Access Compliance Report

Public Rights-of-Way

Intersection ID: 30542	Main Street: AMBERWOOD_CT	Cross Street: SUMMERHILL_RIDGE_DR	Location:	N
ADA ID: 055BF0ADEEDF	Ramp Type: PerpDiag	Initial Pass/Fail: Fail	Overall Compliance: No	Severity Score: 12.5

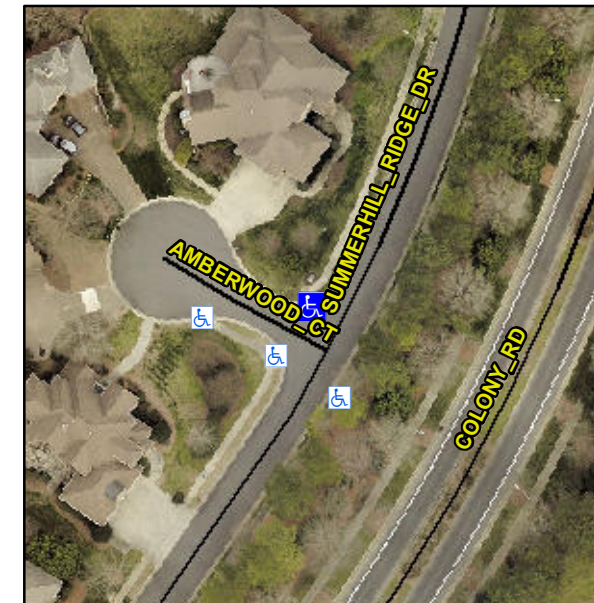
Not Found, R304.5.3

Compliance	Description	Data	Compliance	Description	Data
N/A	Ramp Length (in)	50.0	Yes	Ramp Slope (%)	6.4
Yes	Ramp Width (in)	54.0	No	Ramp XSlope (%)	5.4
N/A	Flare Type LT	N/A	N/A	Flare Type RT	N/A
N/A	Flare Slope LT (%)	N/A	N/A	Flare Slope RT (%)	N/A
N/A	Flare Traversable LT?	N/A	N/A	Flare Traversable RT?	N/A
N/A	Landing Length (in)	N/A	N/A	DWS Provided?	N/A
N/A	Landing Width (in)	N/A	N/A	DWS Contrast?	N/A
N/A	Landing Slope (%)	N/A	N/A	DWS Length (in)	N/A
N/A	Landing X Slope (%)	N/A	N/A	DWS Full Width?	N/A
N/A	Landing Curb? (Y/N)	N/A	N/A	DWS Offset (in)	N/A
N/A	Shared Landing?	N/A			
N/A	Gutter Ponding?	N/A	N/A	Gutter Slope (%)	N/A
N/A	Gutter Lip Ht (in)	N/A	N/A	Gutter X Slope (%)	N/A
N/A	Painted X Walk1?	No	N/A	Painted X Walk2?	No
	X Walk 1 Direction	To SW		X Walk 2 Direction	To SE
N/A	X Walk 1 Width (in)	N/A	N/A	X Walk 2 Width (in)	N/A
	X Walk 1 Slope (%)	1.8		X Walk 2 Slope (%)	5.7
	X Walk 1 X Slope (%)	4.6		X Walk 2 X Slope (%)	0.6

Remove & Replace Curb Ramp With Two New Directional Ramps or Equivalent.
